DESIGN CB	DRAWN BY CB	DART AEROSPACE LTD HAWKESBURY, ONTARIO, CANADA	
CHECKED PH	APPROVED [Signature]	DRAWING NO. DSI 9180	REV. B SHEET 1 OF 1
DATE 06.07.12		TITLE TOW RING	SCALE NTS
A	00.03.08	NEW ISSUE	
B	06.07.12	AN970 WAS AN960

DART SERVICE INSTRUCTION

TO AMEND INSTALLATION INSTRUCTION D205-634 REV. B AND
INSTALLATION INSTRUCTION D204-635 REV. B
REF. CANADIAN STC: SH96-88
FAA STC: SR00563NY

Figure 1 – Tow Ring Amendment

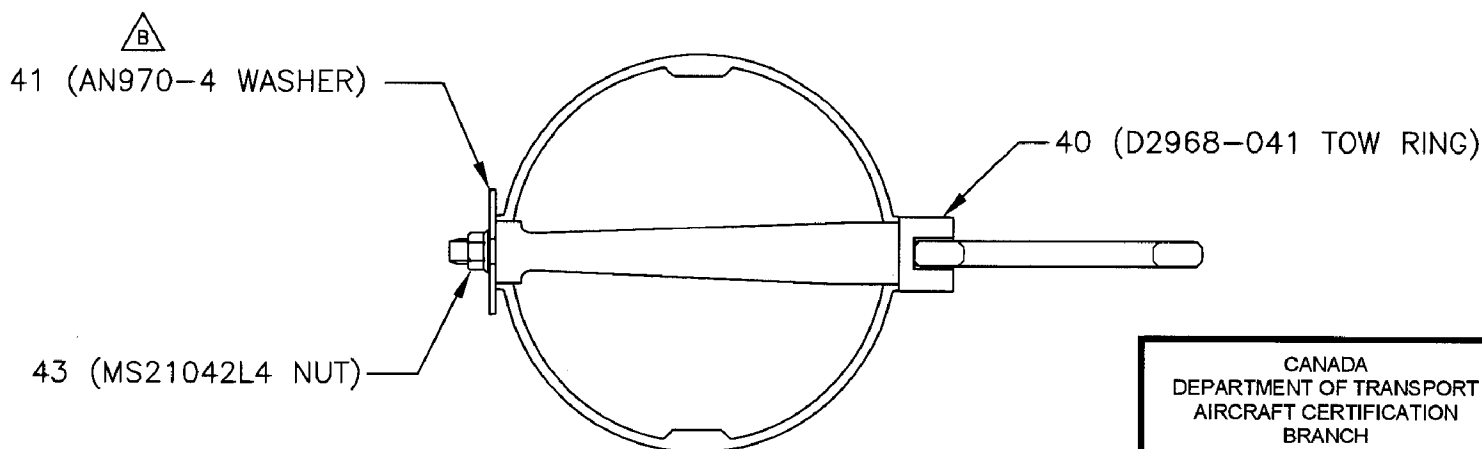
TO AMEND INSTALLATION INSTRUCTIONS PROCEDURE STEP 2 OF D205-634 AND D204-635:
Install tow ring as shown below:
